Project	<b>IEEE 802.16 Broadband Wireless Access Working Group</b> < <a href="http://ieee802.org/16">http://ieee802.org/16</a> >	
Title	<b>BPSK Modulation for IEEE 802.16 WirelessMAN™ OFDM</b>	
Date Submitted	<b>2004-03-14</b>	
Source(s)	<b>Atul Salvekar</b> Voice: 408-545-9577, Fax: 408-545-9888, <a href="mailto:atul.a.salvekar@intel.com">mailto:atul.a.salvekar@intel.com</a> <b>Hassan Yaghoobi</b> Voice: 408-545-6162, Fax: 408-545-9898, <a href="mailto:hassan.yaghoobi@intel.com">mailto:hassan.yaghoobi@intel.com</a>  <b>Intel Corporation</b> <b>CHP3-105</b> <b>350 East Plumeria</b> <b>Dr.</b> <b>San Jose, CA 95134</b>	<b>Vladimir Yanover</b> Voice: +972-36457834 , Fax : +972-36456222, <a href="mailto:vladimir.yanover@alvarion.com">mailto:vladimir.yanover@alvarion.com</a>  <b>Alvarion Ltd.</b> <b>21 A Habarzel St.</b> <b>Ramat - Hahayal</b> <b>Tel - Aviv 69710 P.O.</b> <b>Box 13139,</b> <b>Tel-Aviv 61131,</b> <b>Israel</b>

# BPSK Modulation for IEEE 802.16 WirelessMAN OFDM

**Change 6:**

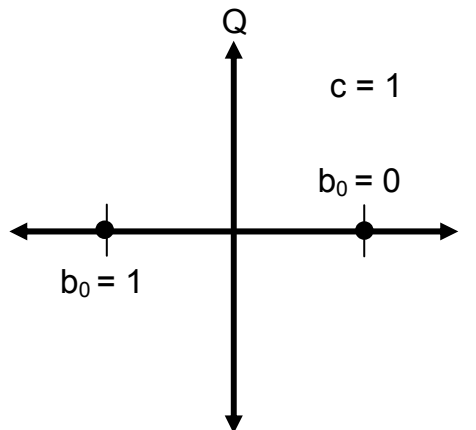
On page 416, Figure 197, add BPSK as follows to the set of constellation options:

Also change the caption on Figure 197 accordingly and as follows:

”BPSK, QPSK, 16-QAM and 64-QAM constellations”
